OVERALL FIRST FLOOR PLAN
SCALE: 1/16" = 1'-0"

DEPT. OF ACCOUNTING & GENERAL SERVICES DIVISION OF PUBLIC WORKS STATE OF HAWAII HILO JUDICIARY COMPLEX JUDICIARY BUILDING HILO, HAWAII	
THIS WORK WAS PREPARED BY ME OR UNDER MY SUPERVISION. <i>Melvin Y. K. Choi</i>		OVERALL FIRST FLOOR PLAN DURRANT MEDIA FIVE DESIGNED BY: DO CHECKED BY: GS DATE: 11-2-11 APPROVED BY: AF DATE: 01-26-04 SCALE: 1/16" = 1'-0" SHEET: 81 OF 437

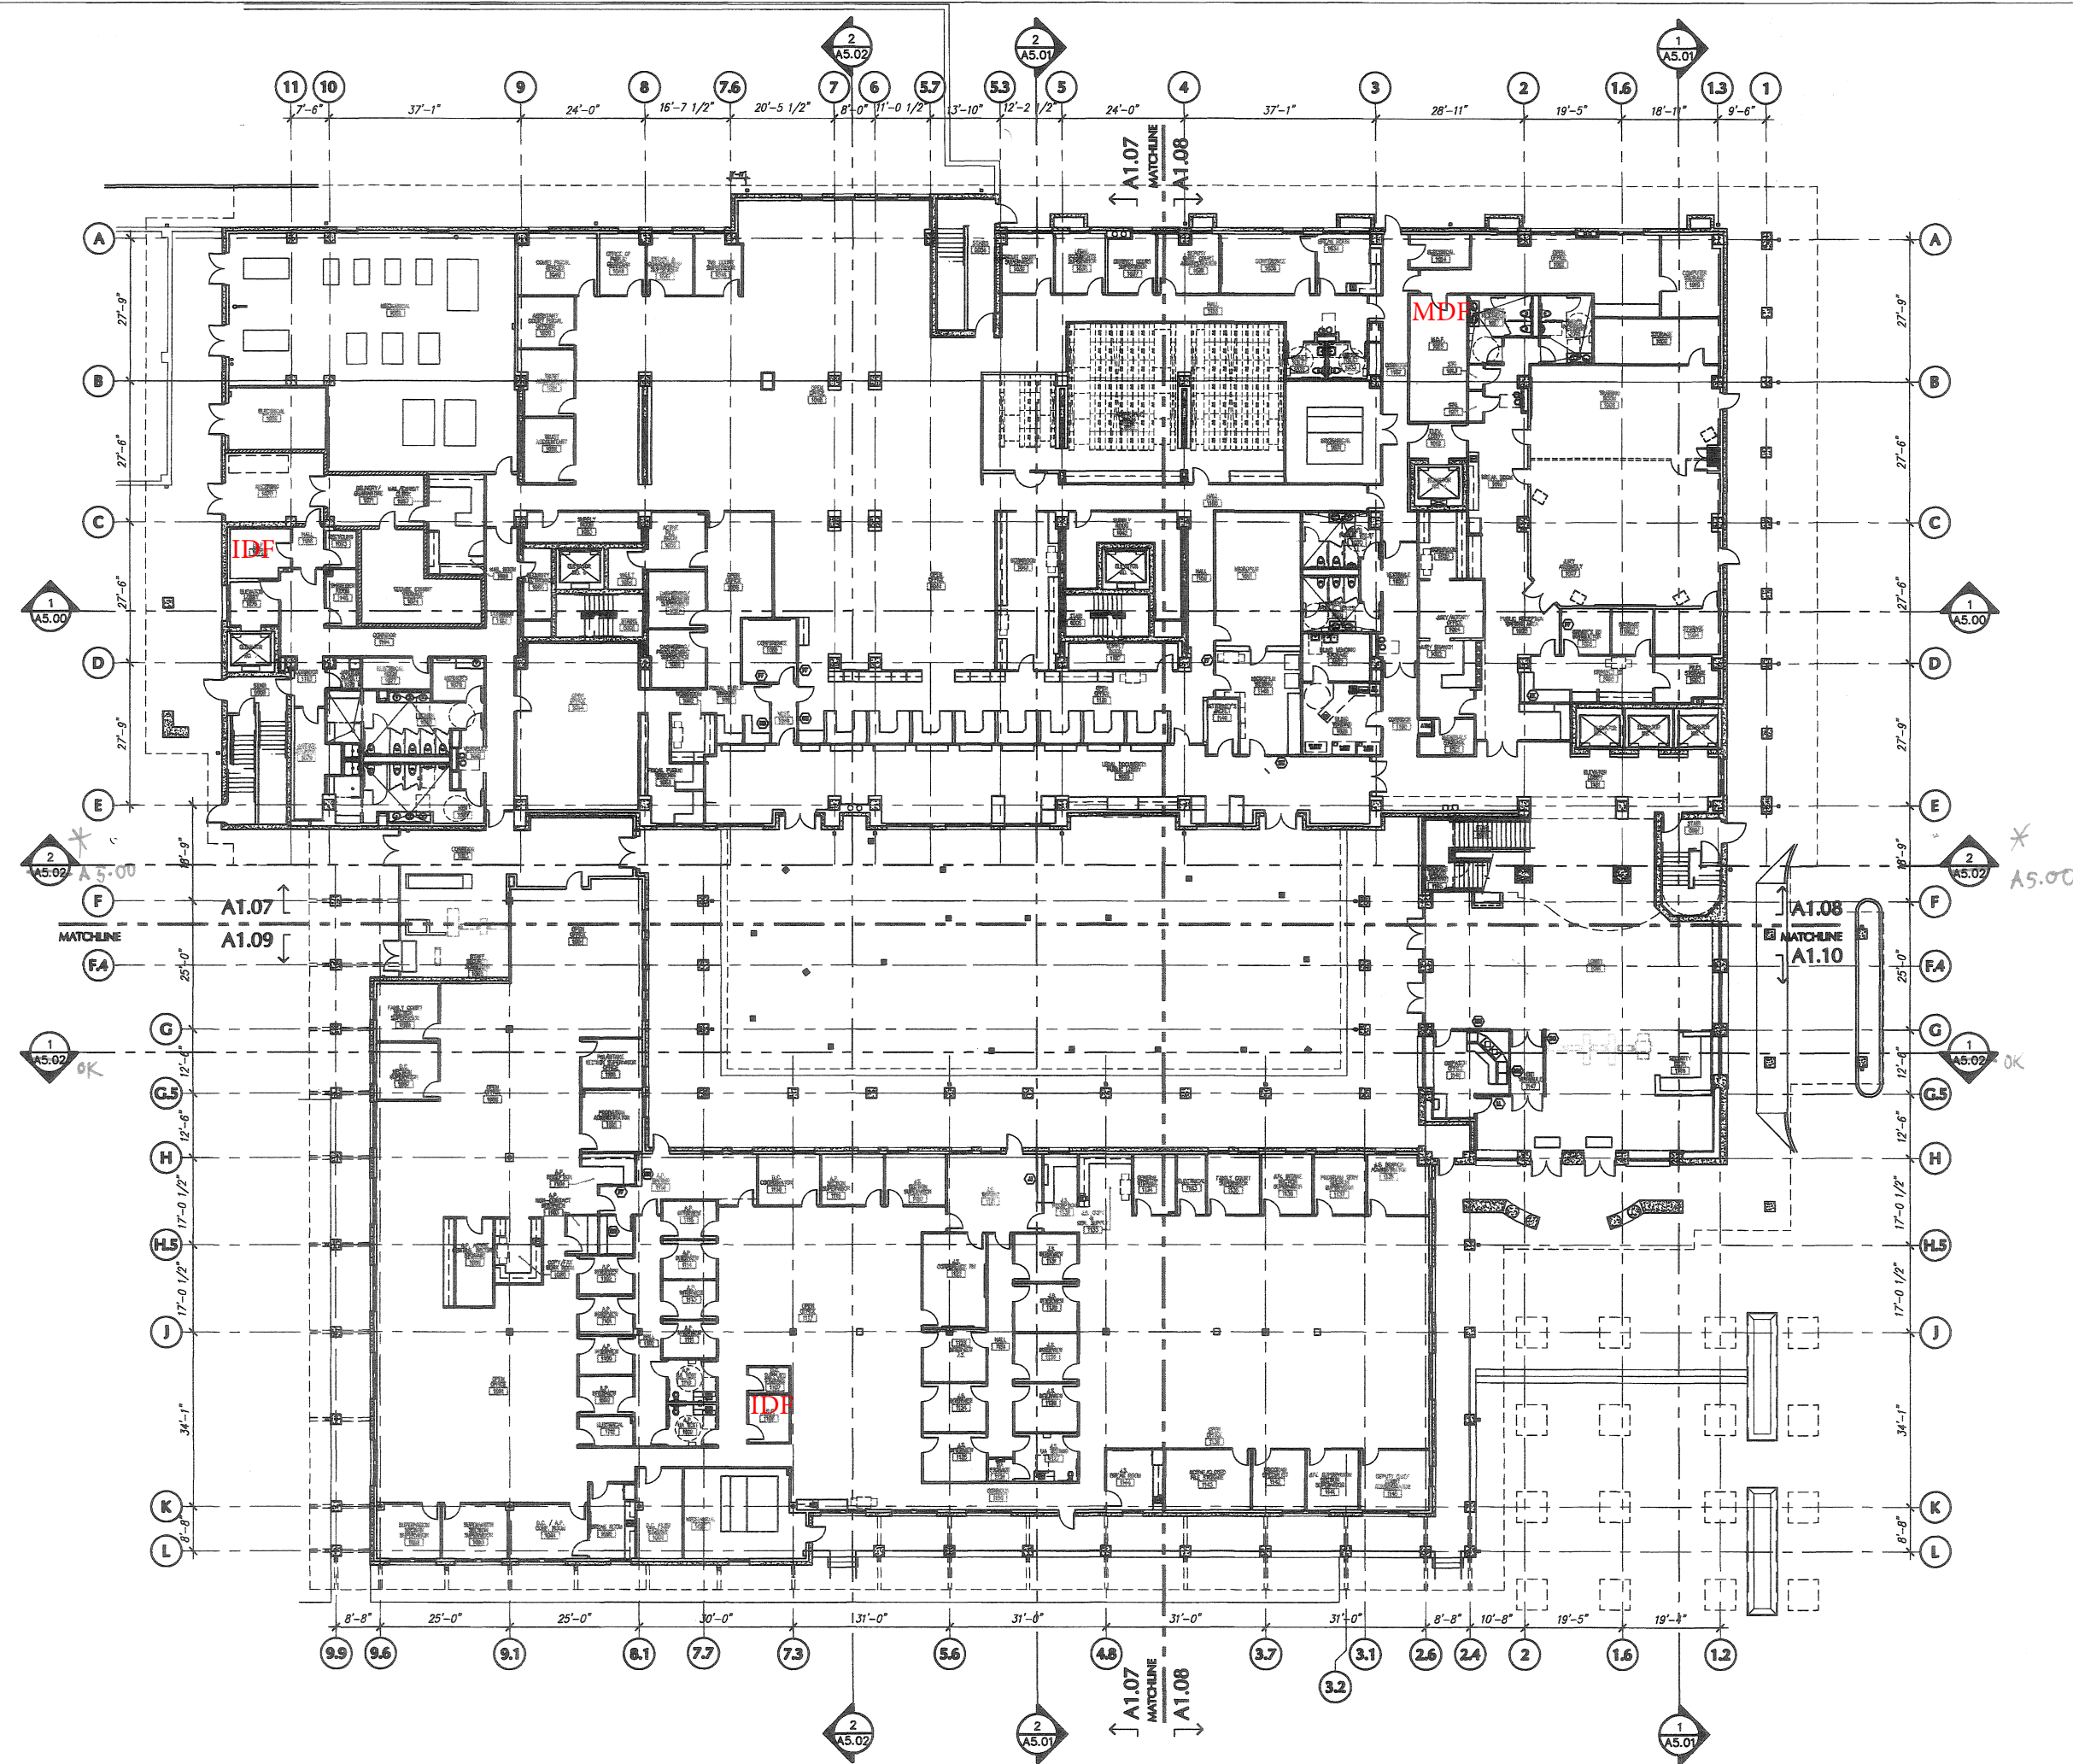
* ASI #3
item 6

OVERALL SECOND FLOOR PLAN
SCALE: 1/16" = 1'-0"

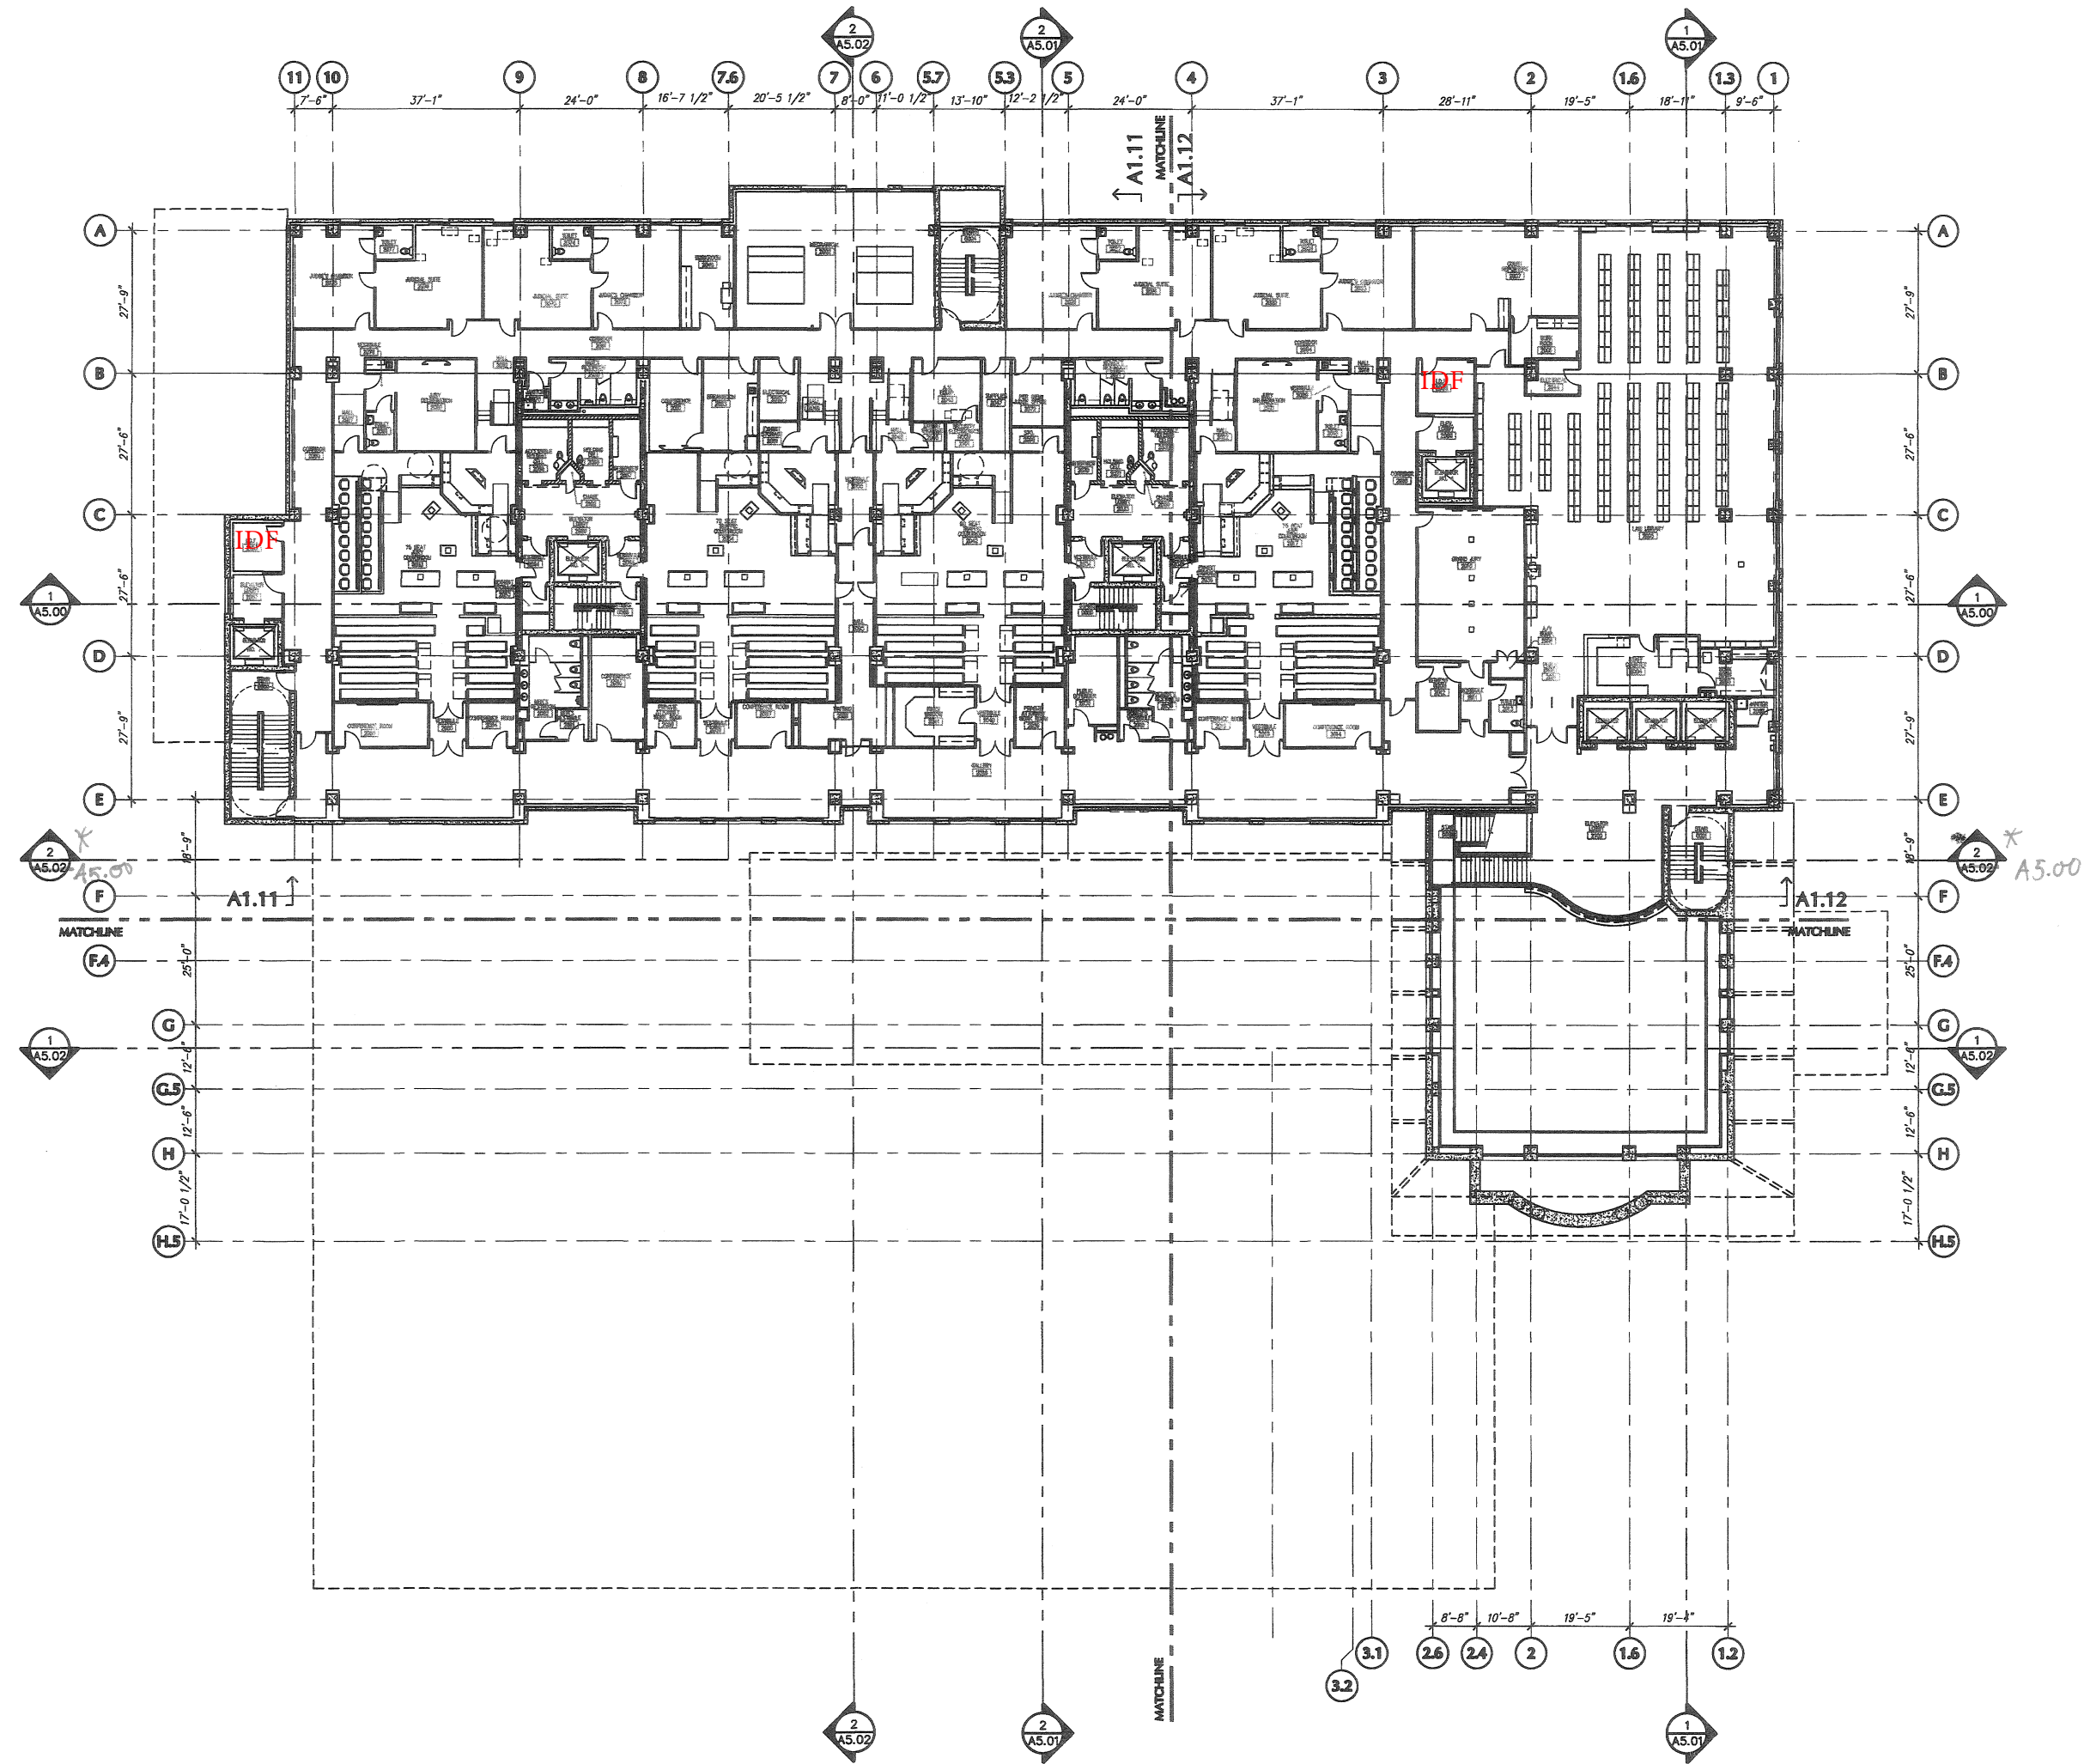
* A51 #3
item 7

OVERALL THIRD FLOOR PLAN
SCALE: 1/16" = 1'-0"

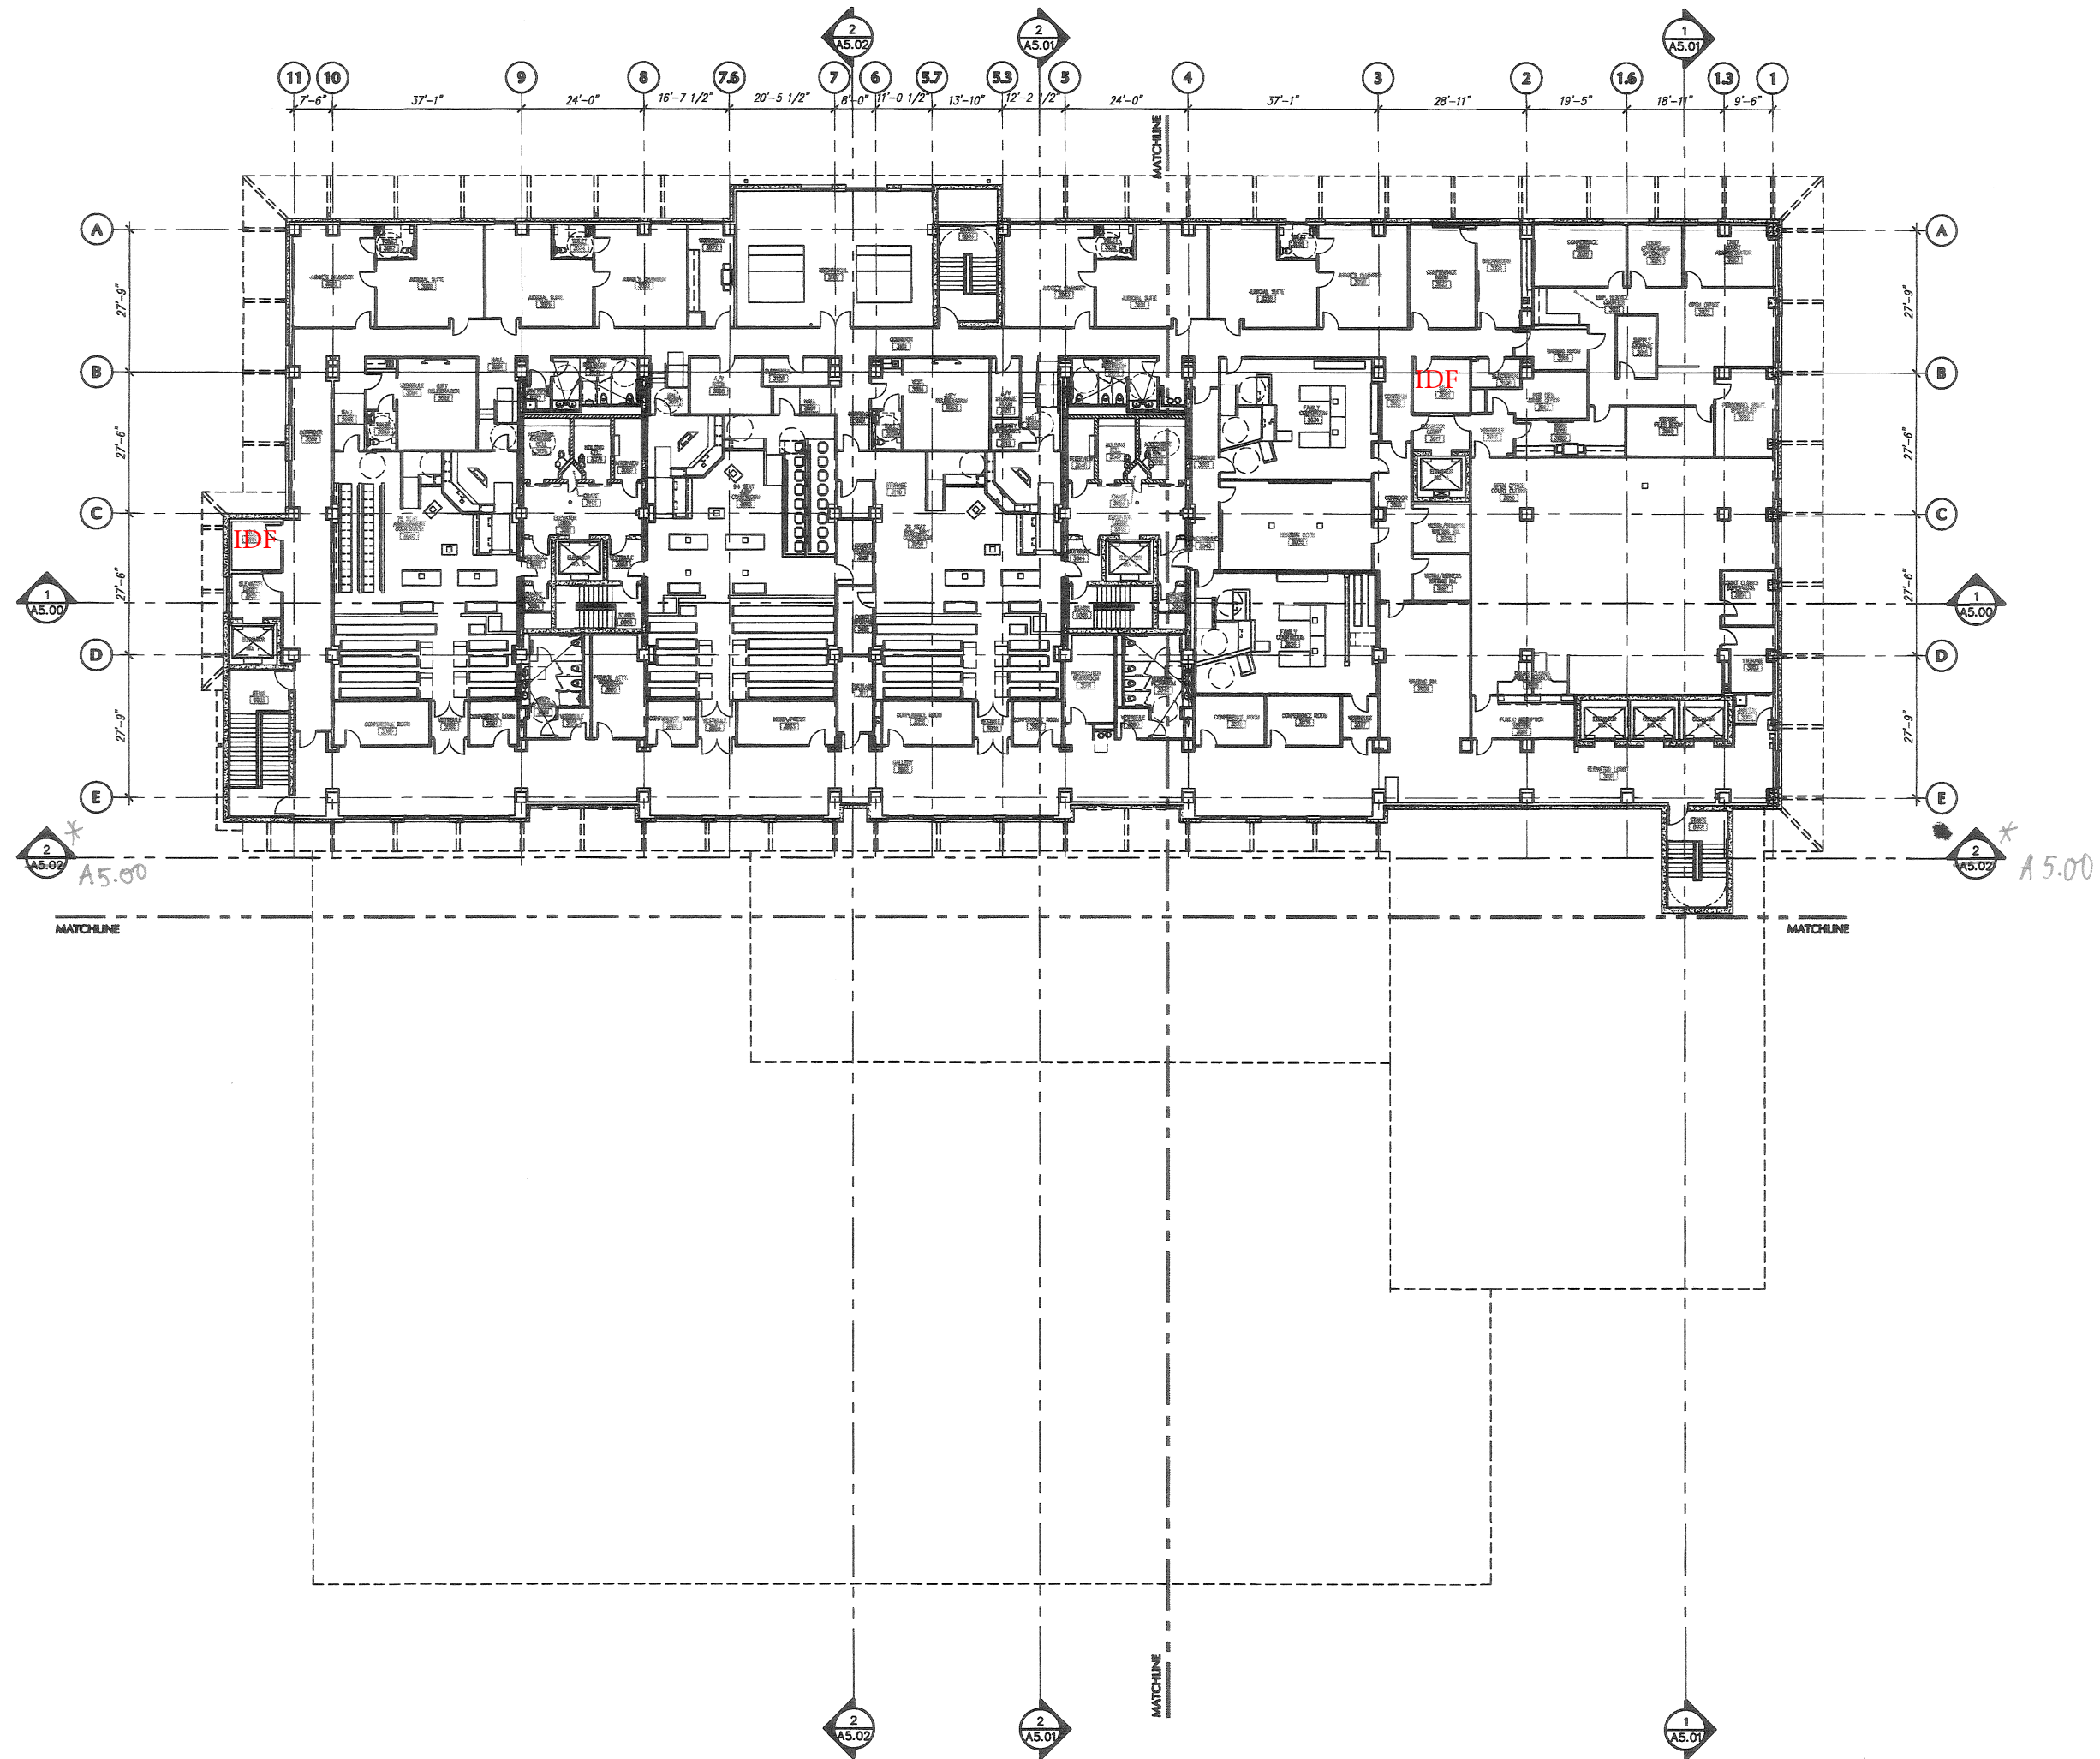
* ASI #3
item 8
